NRC DISTRIBUTION FOR PART 50 DOCKET MATERIAL

PLANT NAME: OCONEE UNITS 1-3
jcm 09/19/77

ENCLOSURE License No. DPR-38, 47, and 55 to
Appl for Amend: tech specs proposed change concern
ing changes to the pressurization, heatup and
cooldown limitations for Oconee Unit # 3...w/att
Rept entitled: "Analysis of Capsule OCIII-A From
Duke Power Co. Oconee Nuc. Station, Unit # 3 -
Reactor Vessel Materials Surveillance Program -
BAW-1438 - July 1977...

RE: Oconee Nuclear Station
Docket Nos. 50-269, -270, -287

Figure 3.1.2-1C

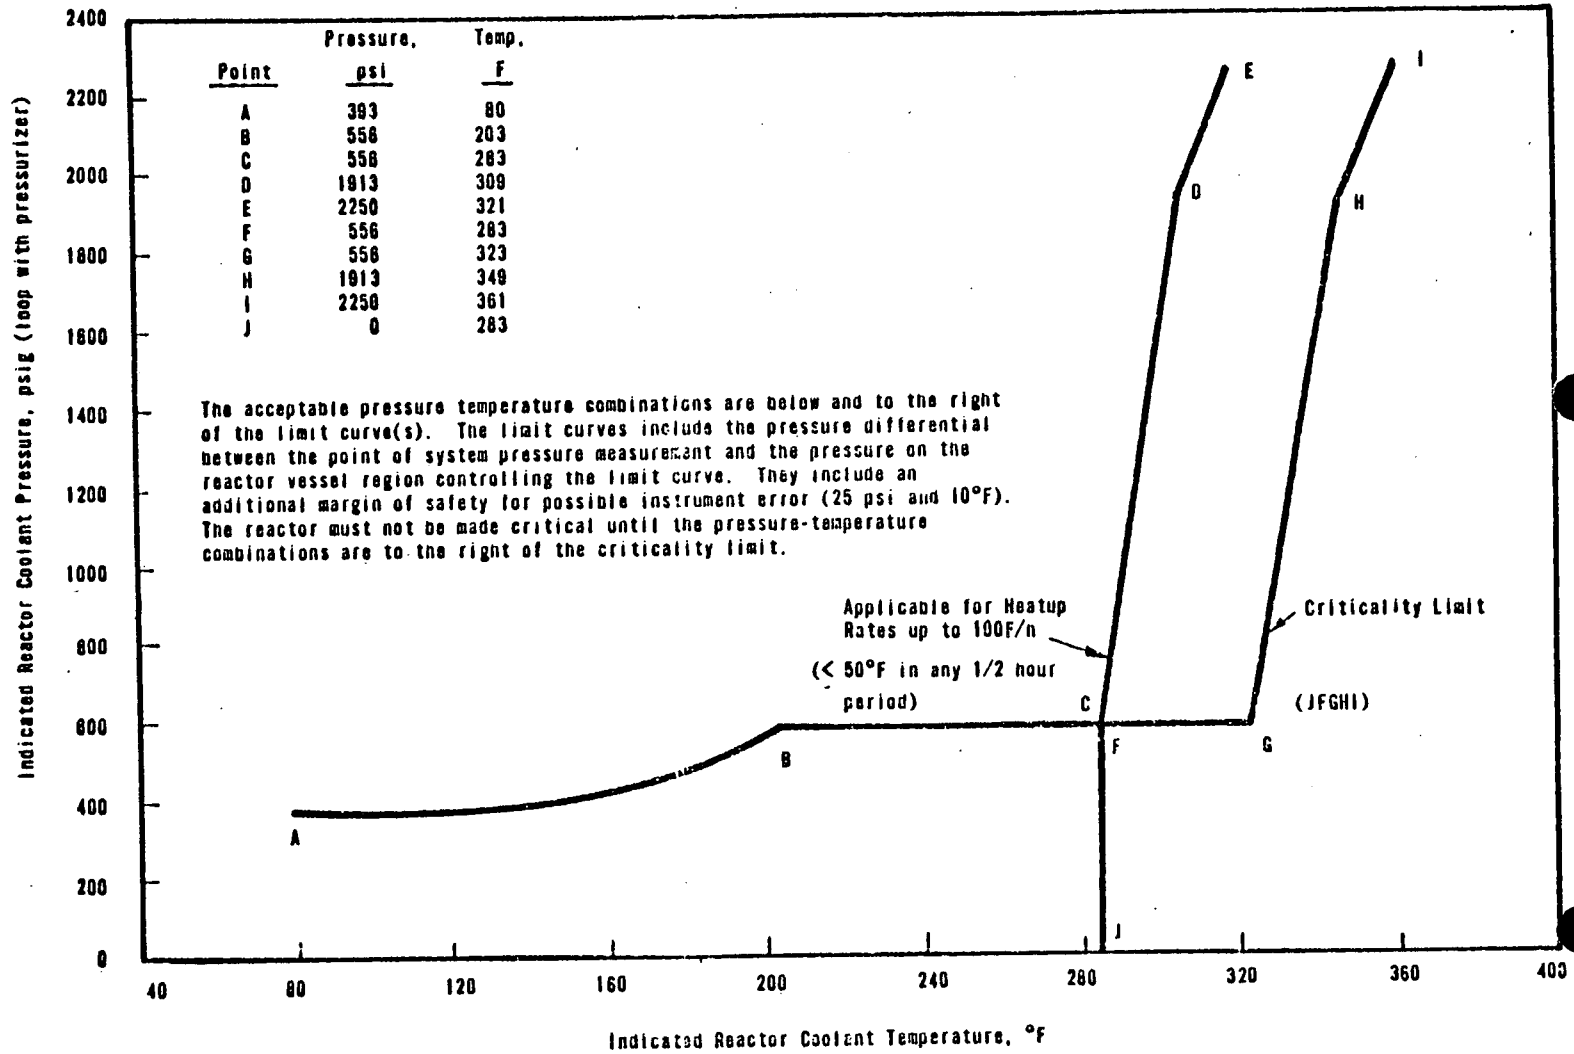
Heatup rates and allowable combinations of pressure and temperatures shall be limited in accordance with Figure 3.1.2-1A Unit 1
3.1.2-1B Unit 2
3.1.2-1C Unit 3.

UNIT 3
 REACTOR COOLANT SYSTEM
 NORMAL OPERATION HEATUP LIMITATIONS
 APPLICABLE FOR FIRST 8.0 EFY

Figure 3.1.2-2C

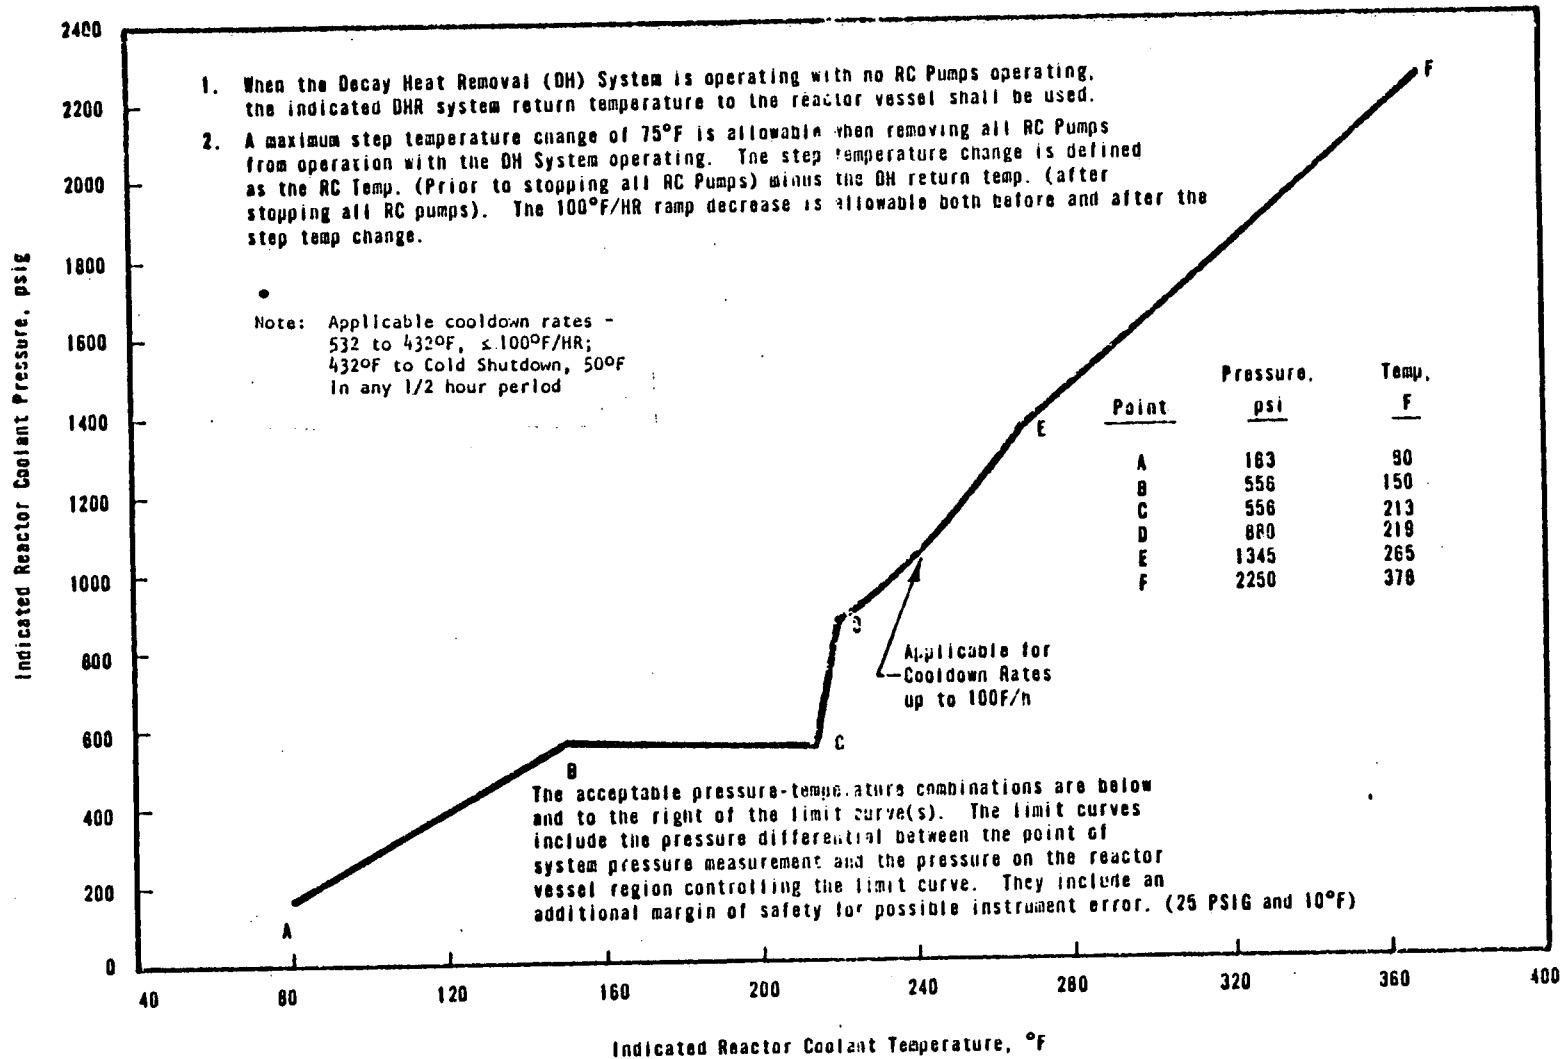
Cooldown rates and allowable combinations of pressure and temperature shall be limited in accordance with Figure 3.1.2-2A Unit 1
3.1.2-2B Unit 2
3.1.2-2C Unit 3.

UNIT 3
 REACTOR COOLANT SYSTEM
 NORMAL OPERATION COOLDOWN LIMITATIONS
 APPLICABLE FOR FIRST 8.0 EFY

Figure 3.1.2-3C

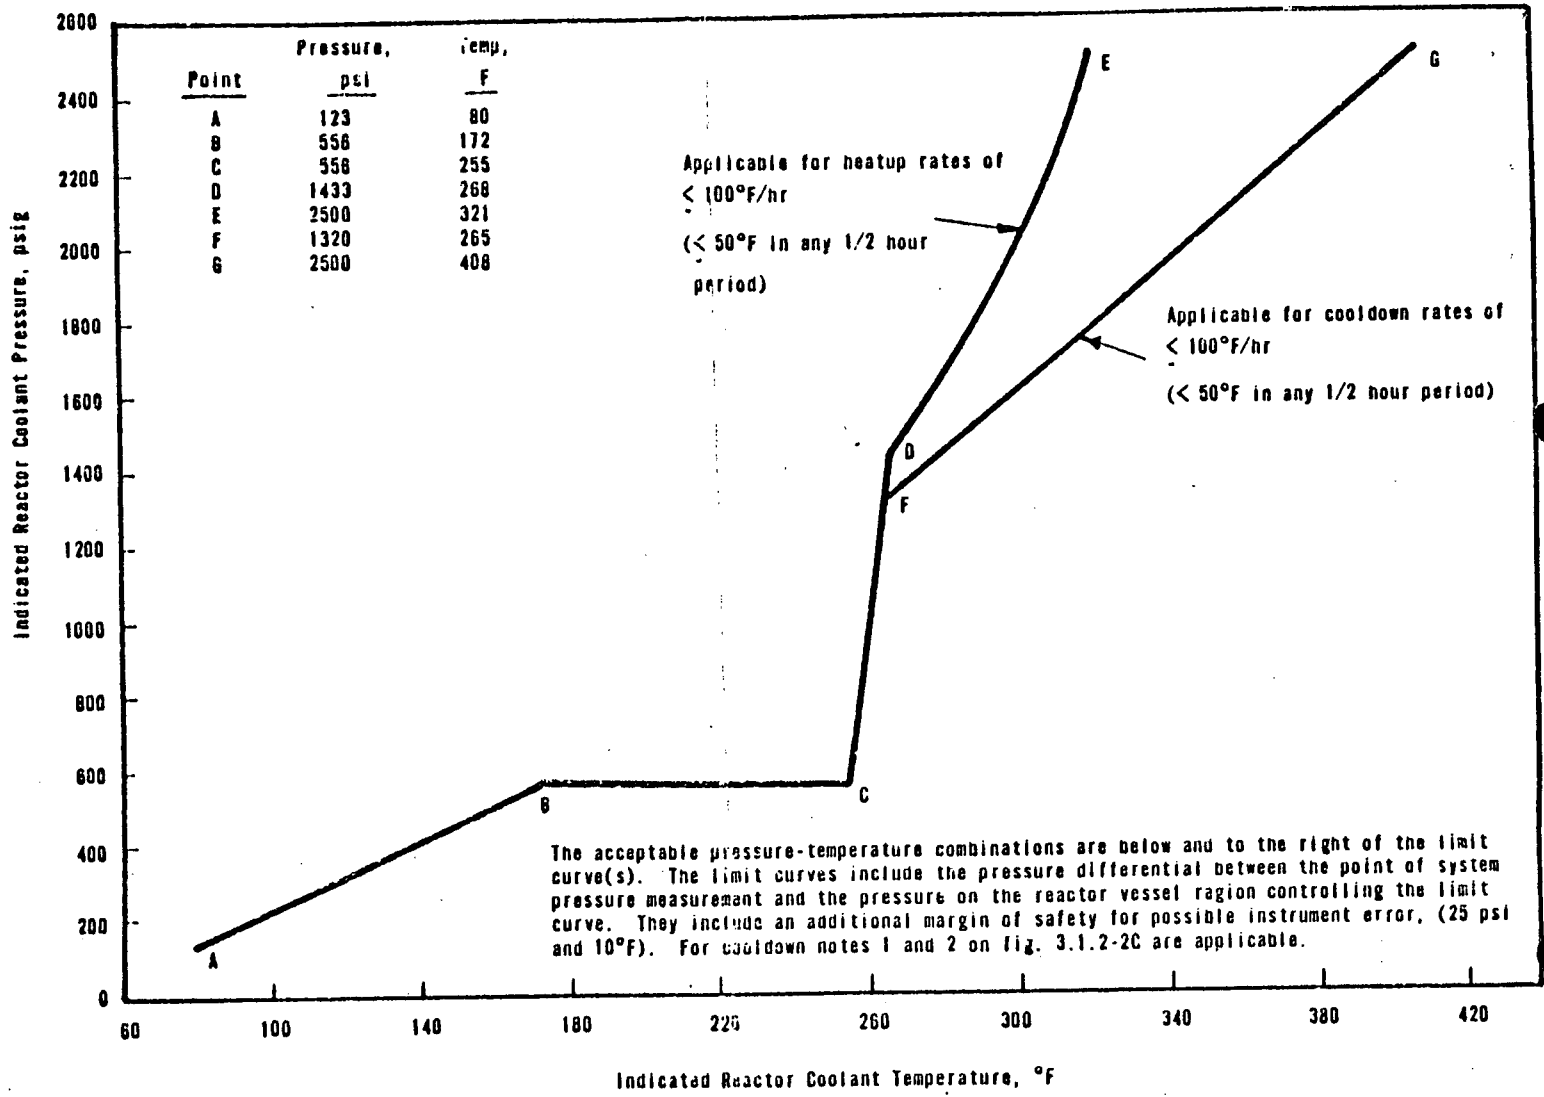
For thermal steady state system hydro test the system may be pressurized to the limits set forth in Specification 2.2 when there are fuel assemblies in the core under the provisions of 3.1.2: 1 and to ASME Code Section III limits when no fuel assemblies are present provided the reactor coolant system is to the right of and below the limit line in Figure 3.1.2- 3A Unit 1
3.1.2-3B Unit 2
3.1.2-3C Unit 3.

UNIT 3
 REACTOR COOLANT SYSTEM
 INSERVICE LEAK AND HYDROSTATIC
 TEST AND COOLDOWN LIMITATIONS
 APPLICABLE FOR FIRST 8.0 EPY
